**SEQUOYAH FUELS CORPORATION
RESPONSE TO REQUEST FOR
ADDITIONAL INFORMATION
GROUND WATER CORRECTIVE
ACTION PLAN REVIEW**

Subject: Sequoyah Fuels Corporation, Docket – 40-8027
Request for Additional Information – Groundwater Corrective
Action Plan (TAC L52528)

Responses to NRC RAIs of September 28, 2005
Ground Water CAP Review

FIGURE 8-52
 MODELED NITRATE MAXIMUM INITIAL CONCENTRATIONS

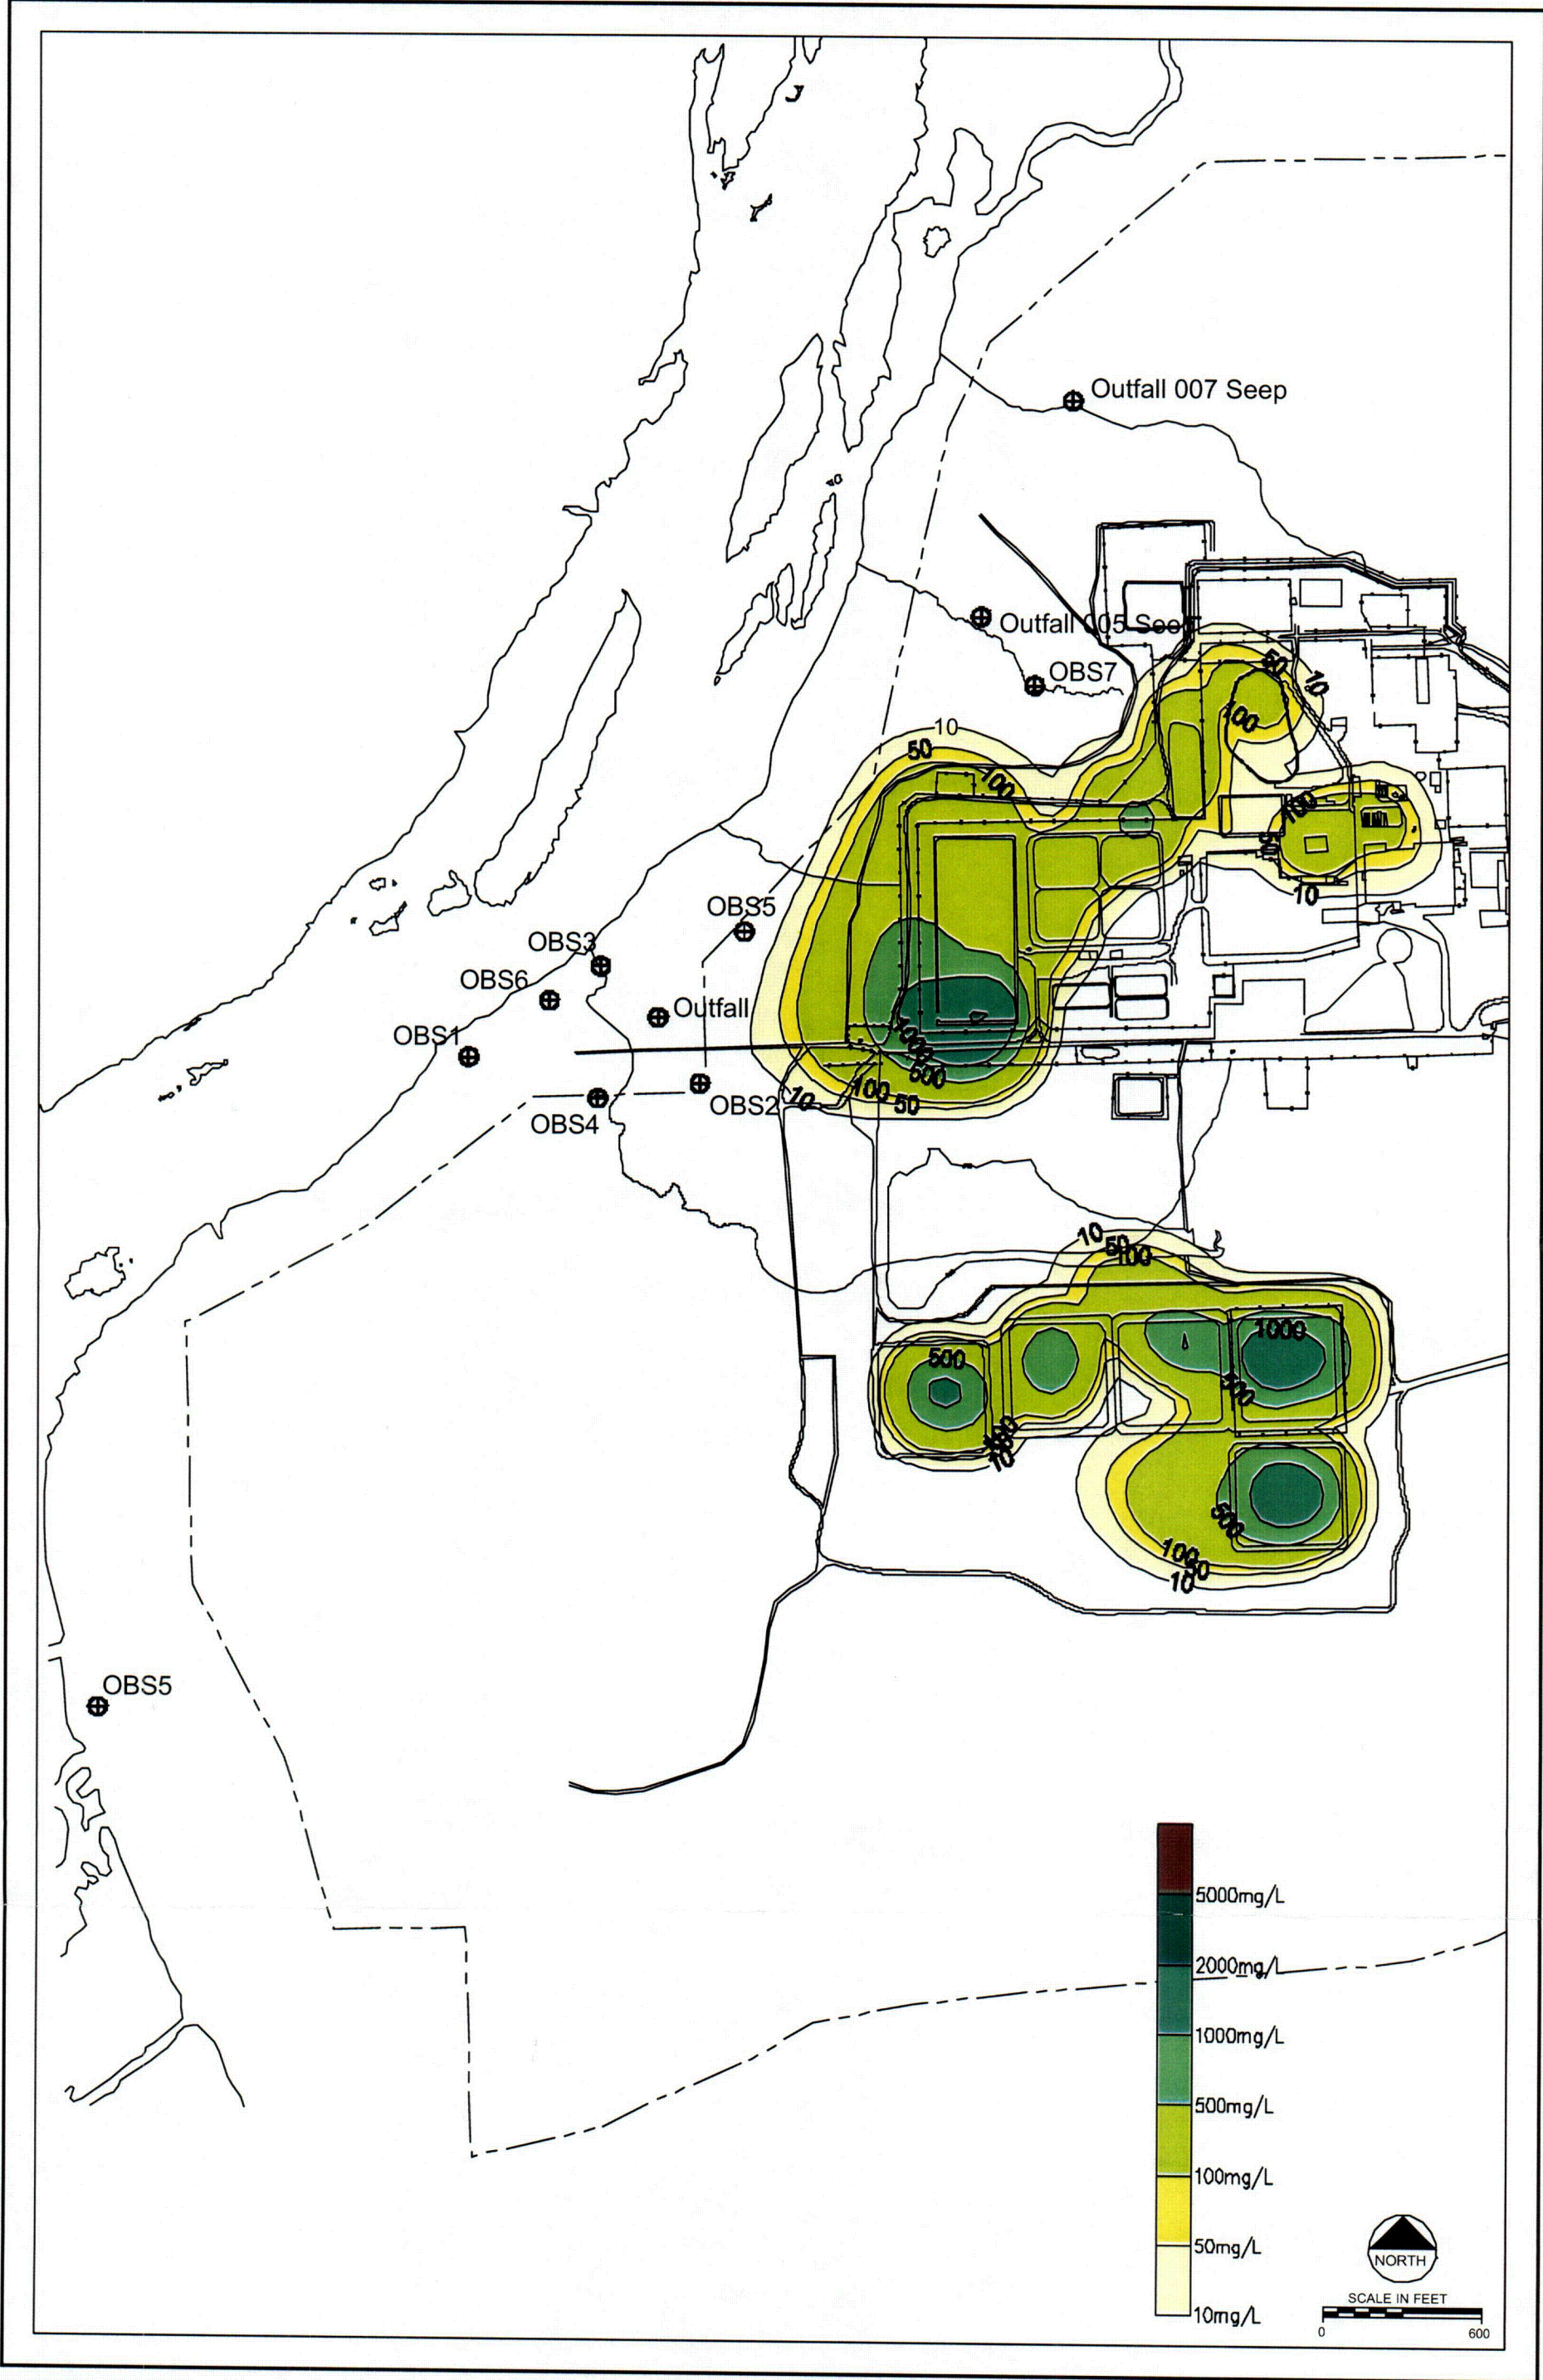
- C. According to the March 14, 2005, response to NRC's request for additional information, the proposed remedial action appears to allow elevated nitrate and arsenic concentrations to enter the Kerr Reservoir. Nitrates tend to impact water quality by promoting algal and protozoa growth, which, in-turn, decreases dissolved oxygen levels endangering aquatic habitats. Elevated nitrate levels also impact water quality for domestic use. Arsenic is a toxic metal that can stress aquatic fauna at low concentrations, depending on the species. Please provide justification for allowing elevated nitrate and arsenic levels to enter the surface water system.

The maximum predicted ground water concentrations of nitrate at any of the model observation points used for model predictions (see Figure 8-52) is approximately 315 mg/L in observation point number 4 in multiple layers (OBS4, Figure 8-52) at approximately 15 years from the start of the model run. Current site characterization data indicate that the only current discharge of nitrate to the river is through ephemeral stream flows. The modeled peak current concentration of nitrate to the river through stream drainage discharge is below the MCL of 10 mg/L (HGSCR Figure 8-83) though the nitrate concentrations in the seeps is higher (see response to RAI CAP2F).
